**MEMO**  
**LIMELIGHT HOTEL DESIGN REVIEW SUBCOMMITTEE**  
**SPECIAL MEETING OF APRIL 22, 2015**

**PROJECT:** Limelight Hotel, formerly Bald Mountain Lodge

**REQUEST:** Community Core Design Review Modification

**REVIEWER:** Rebecca F. Bundy, Senior Planner / Building and Development Manager

BICYLCE RACK LOCATIONS 4.14.15

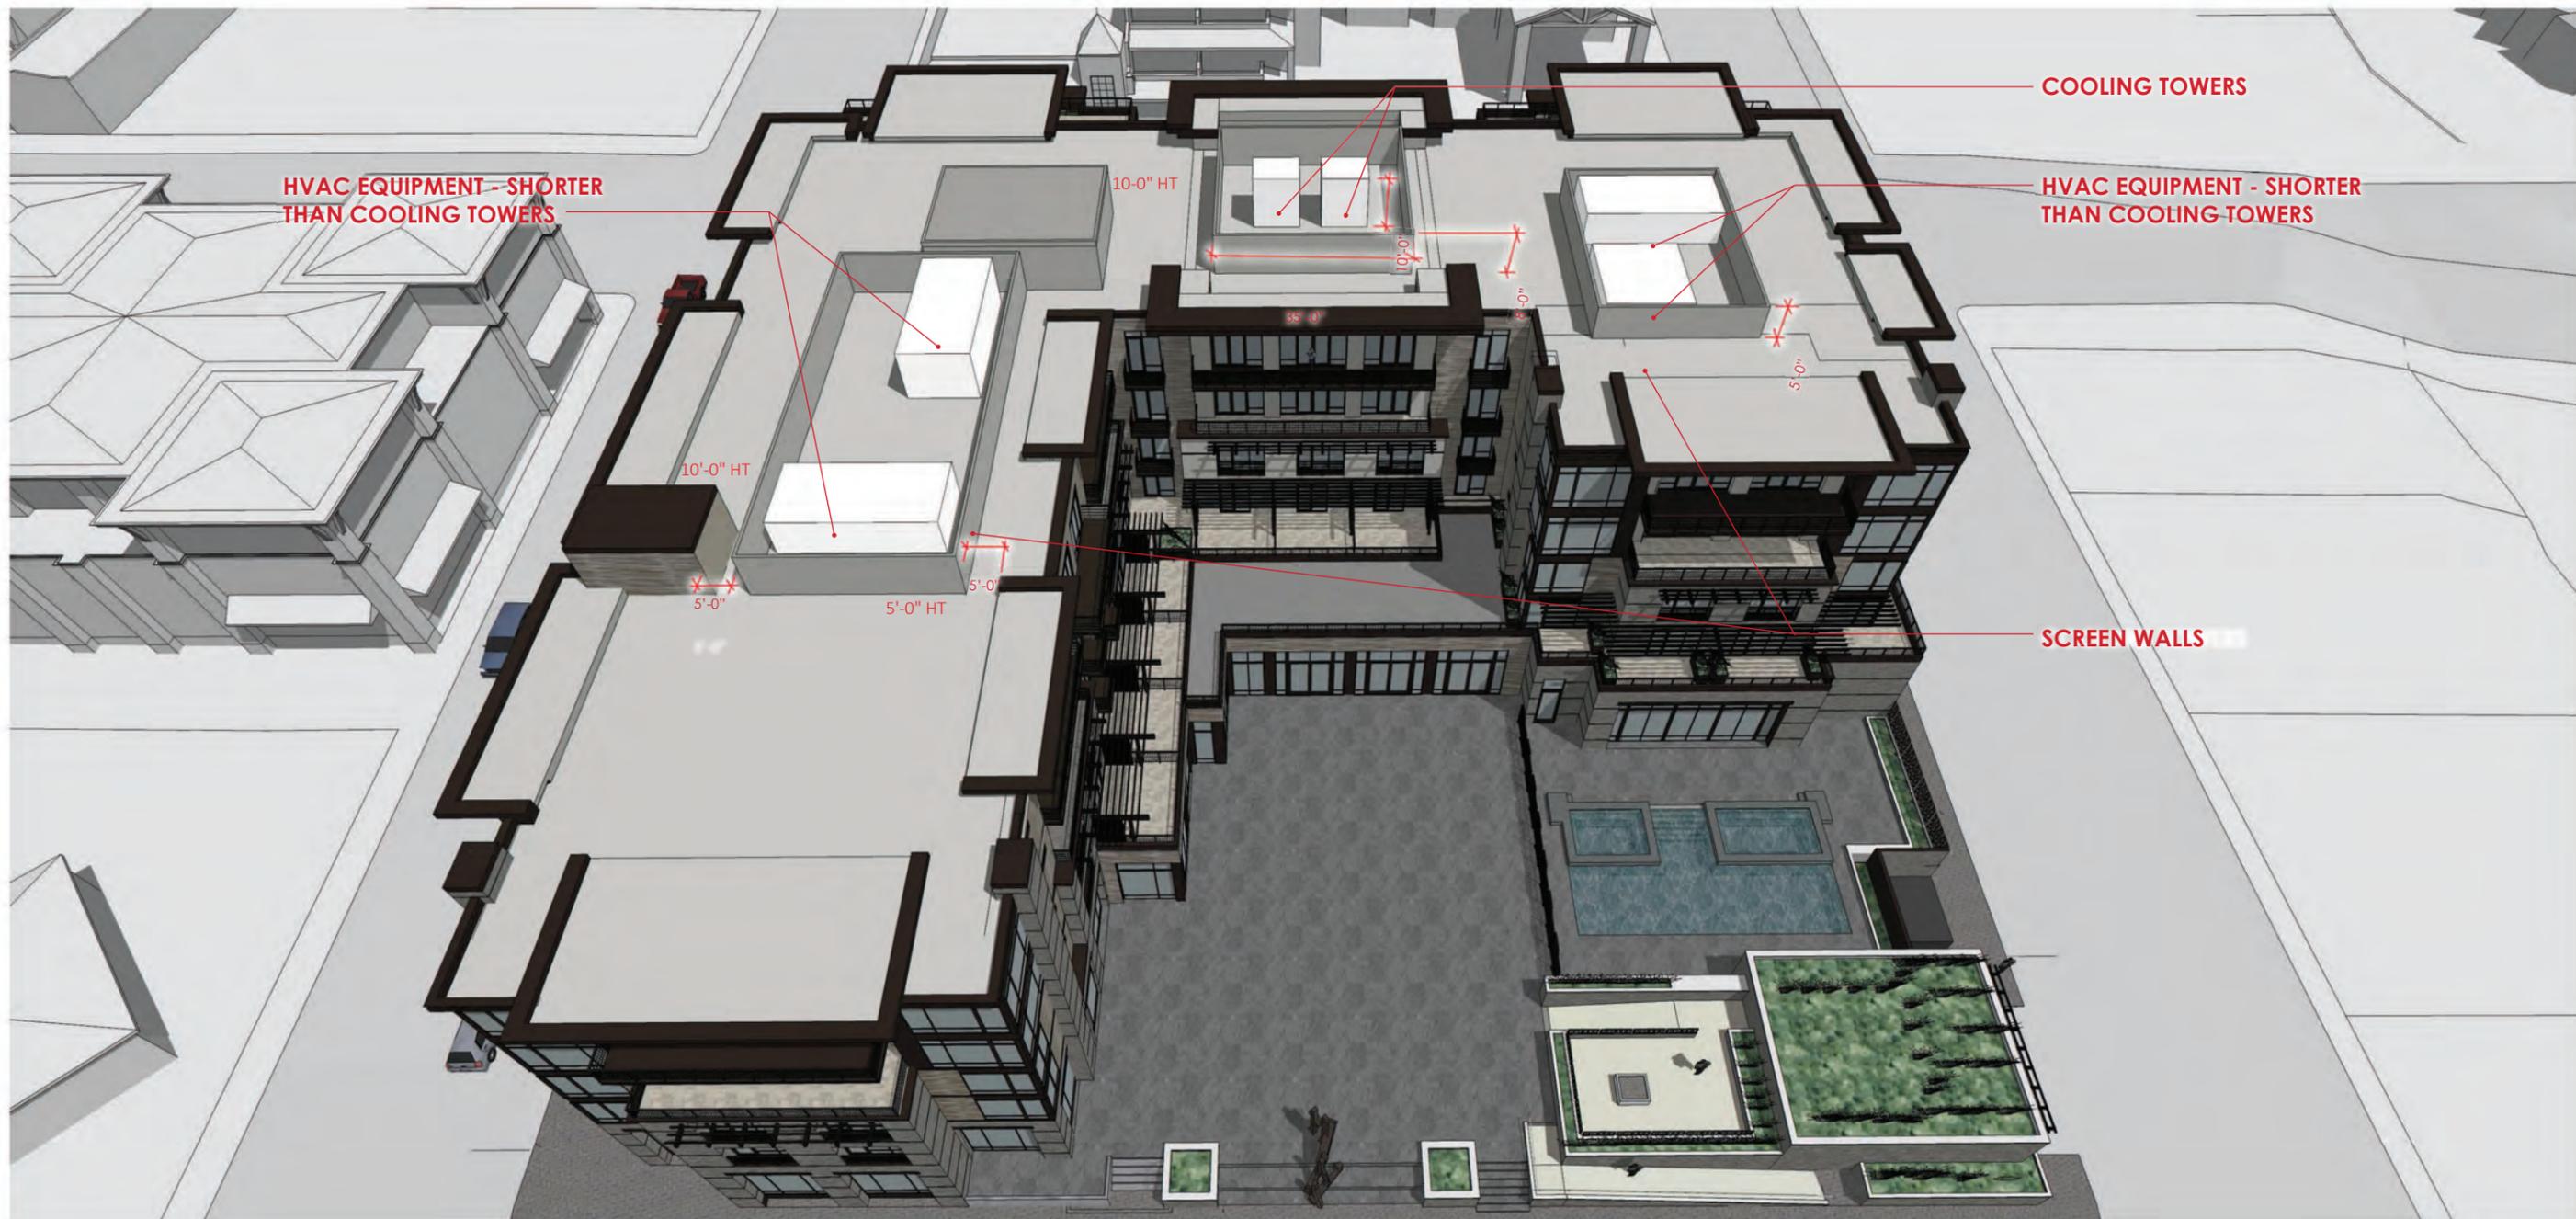
<i>Staff Comments</i>	<p><i>12 bicycle racks have been proposed to accommodate parking for 24 bicycles. 24.6 bicycle parking spaces are required, based on the vehicular parking requirement of 123 spaces. However, additional bicycle parking is proposed to be provided on-site and within a 680 sf room in the building. The applicant should provide more information about bicycle parking on-site and within the building.</i></p>
<input checked="" type="checkbox"/>	<input type="checkbox"/>	<input type="checkbox"/>	17.64.020.X.1. Streets And Streetscapes	<p>a. Streetscape improvements shall be designed in compliance with the city approved cross sections for downtown streets.</p> <p>b. On street parallel parking spaces shall have a dimension of eight feet by twenty feet (8' x 20') (for non-ADA accessible spaces). On street angled parking spaces shall be provided at a forty five (45) to sixty degree (60°) angle. Angled parking spaces shall have a depth of eighteen feet (18') (as measured perpendicular from the curb face), and a width of nine feet (9') (as measured perpendicular to the stripes of the parking stall). A minimum distance of twenty feet (20') is required from the crosswalk or stop sign line to the first parking space.</p> <p>c. The sidewalk radius at street intersections shall be minimized to shorten the length of pedestrian crossings and to prevent vehicles from making turns at high speeds. The city of Ketchum streets department and fire department shall determine the minimum sidewalk radius when designing streetscape improvement plans.</p> <p>d. All streetlight fixtures, traffic signals, traffic and directional signs, pedestrian wayfinding signs, parking signs, bicycle racks, parking meters, and fire hydrants shall be located within one to three feet (3') of the curb face.</p> <p>e. All streets shall be designed with streetlights. Streetlights shall be provided along all sidewalks at spacing intervals not to exceed sixty feet (60').</p> <p>f. Streetscape furniture and amenities shall be located to maintain a clear pedestrian path of at least five feet (5') in width.</p> <p>g. If permitted, tables, chairs, and other obstructions used for sidewalk dining shall be located to maintain at least five feet (5') of unobstructed sidewalk width.</p> <p>h. All streetlights, streetscape furniture, and amenities shall be consistent with a city approved list of approved furniture.</p>

Rooftop Perspective

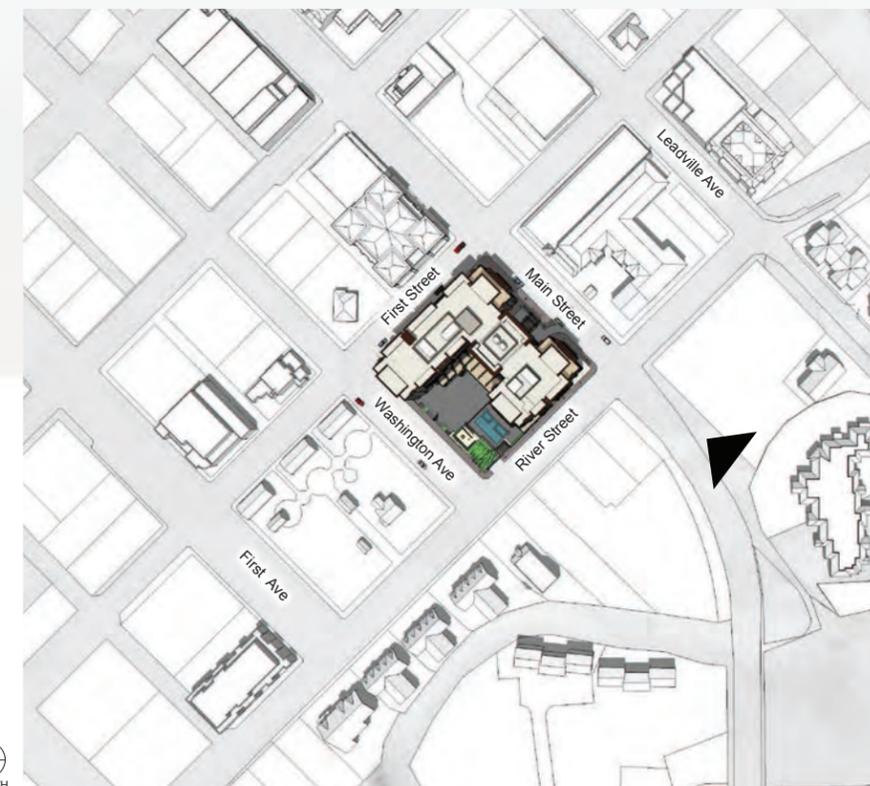
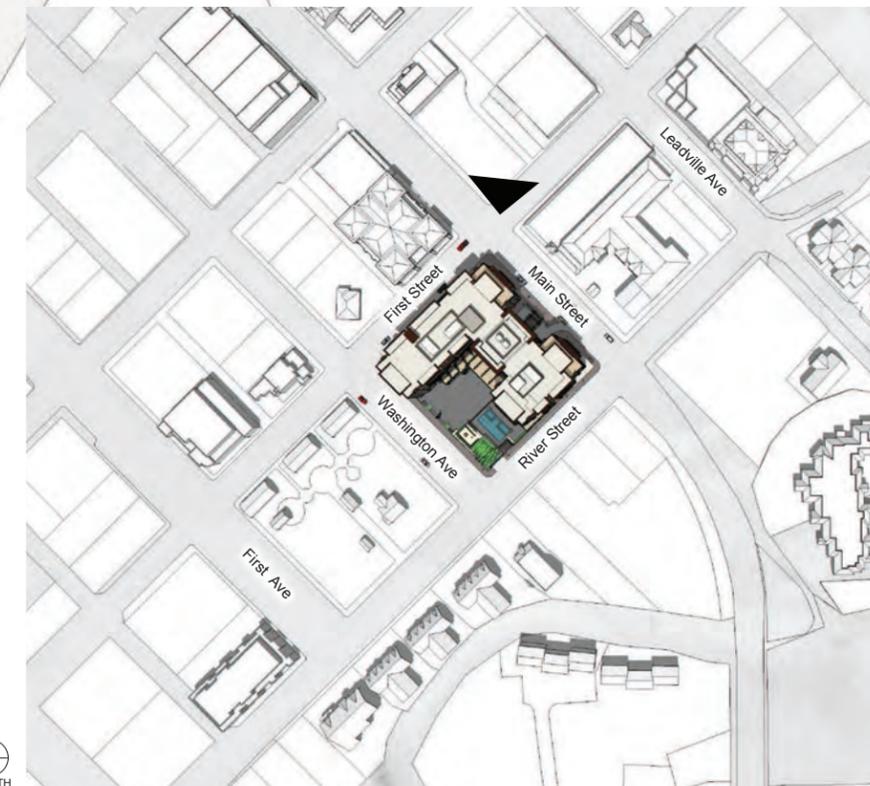
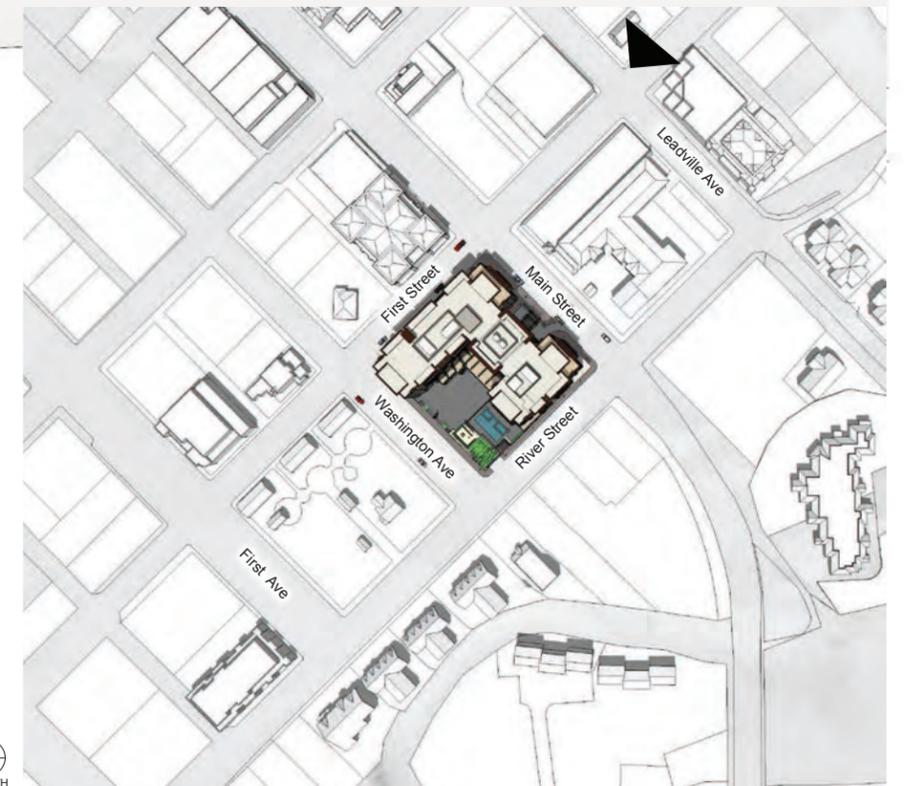
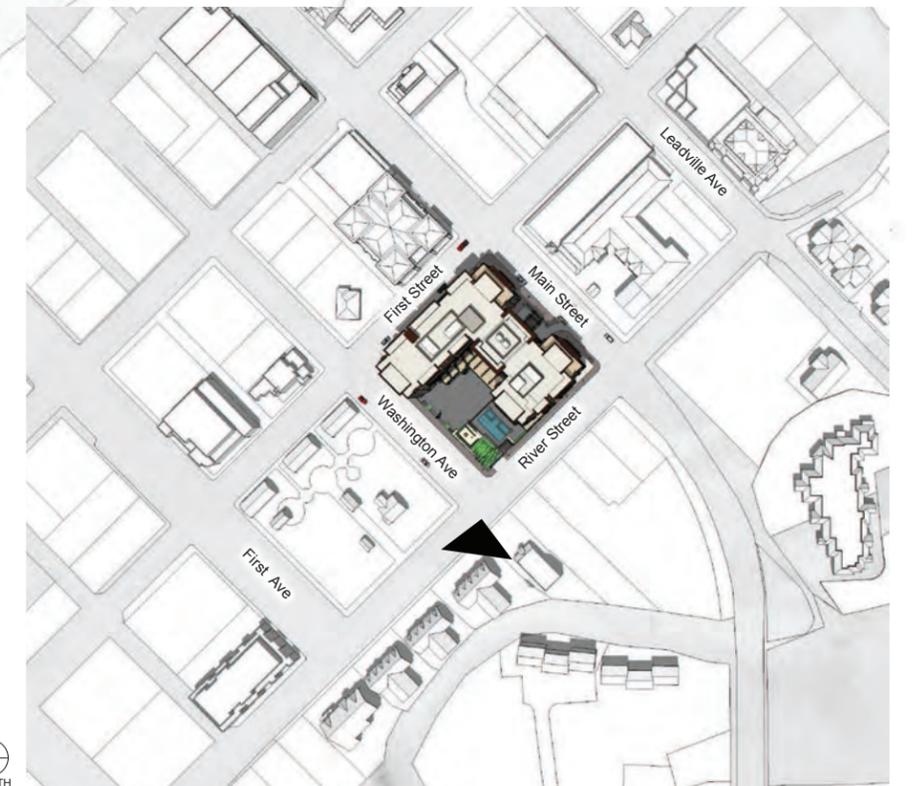
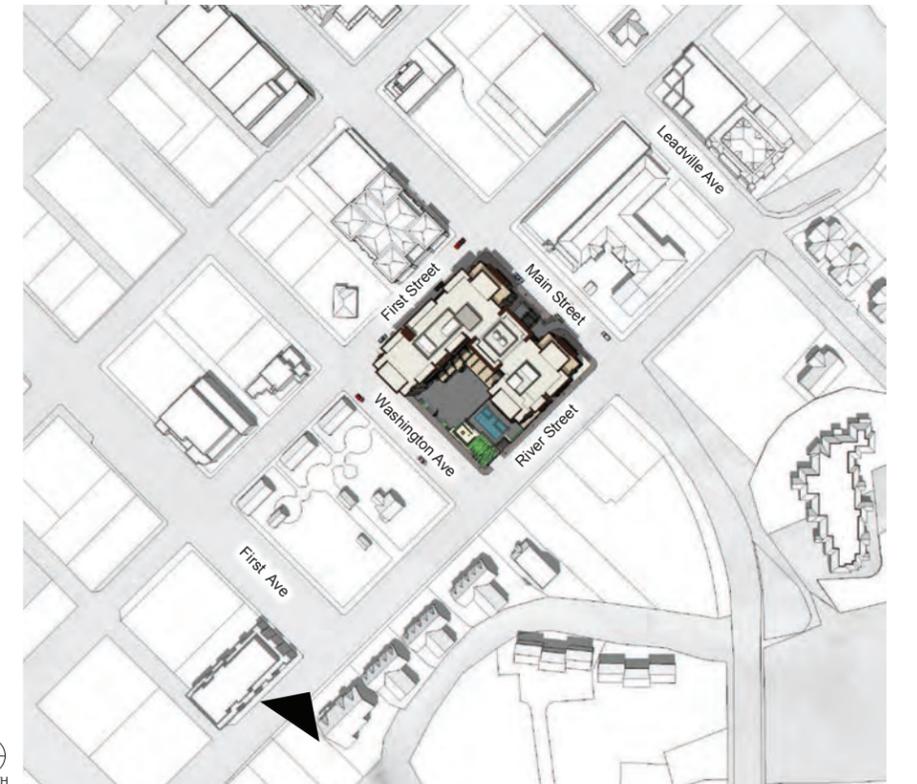
<i>Staff Comments</i>	<i>The Commission has approved the flat roof design, rooftop stair access and elevator overrun, but asked the applicant to provide greater detail on the rooftop mechanical screening. The applicant has determined the necessary height of the cooling towers, proposed to be located at the center of the roof above the main lobby. They are proposed at ten feet in height, with an eight foot tall screening fence. A three foot tall roof pop-up at that location has been eliminated to help lower the height of the cooling towers. The remaining HVAC equipment will be lower than the cooling towers and will be screened by five foot tall screening fences. The rooftop access stair tower and elevator overrun are proposed to be ten feet tall above the roof. By changing to a flat roof design and eliminating the roof pop-up, the tallest rooftop items exceed the allowed building height by about 4.5 feet. The code allows rooftop accesses to exceed the allowed building height by ten feet and does not address the height of rooftop mechanical equipment. Please refer to the applicant's Rooftop Equipment Screening renderings to see the visibility of the rooftop items from vantage points on Main, First and River Streets.</i>
